MODEL
61

CARBURETTOR SUPPORT + “VAPOUR LOCK KIT”

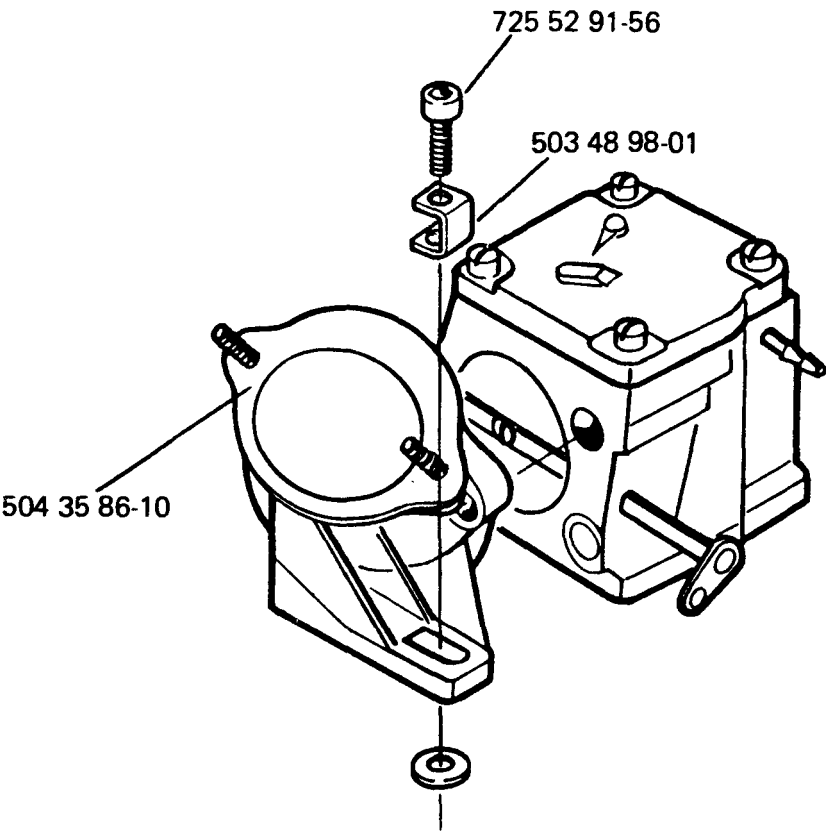
As on the model 266, a carburettor support is introduced. The air filter holder is therefore attached to the crankcase. At the same time, the material in the manifold is changed in order to improve the hot starting characteristics.

The change is introduced from serial number 61 7140387.

In order to assemble the new carburettor support (the Ref. No. 504 35 86-10 remains) on saws with lower serial number than the above, the following is required:

Mount carburettor and air filter holder without spacer 501 53 58-01. Use the new filter holder as a template, a hole, ø 3.3 mm (118”), should be drilled in the crankcase and be threaded with thread tap M4.

Mount screw 725 52 91-56 with clip 503 48 98-01. For saws without a prepared post in the crankcase, also a washer should be mounted between clip and crankcase.

The cylinder cover must also be exchanged to a new one with a modified middle wall. See below. New cover keeps its reference number.

New Ref. No.	Description	Excluded Ref. No.	Remark
501 53 38-02	Manifold	501 53 38-01	
501 25 09-02	Gasket {carburetor}	501 25 09-01	
501 25 10-02	Gasket (manifold)	501 25 10-01	
725 52 91-56	Screw		
503 48 98-01	Clip		
—	Spacer	501 53 58-01	Remains as a spare part
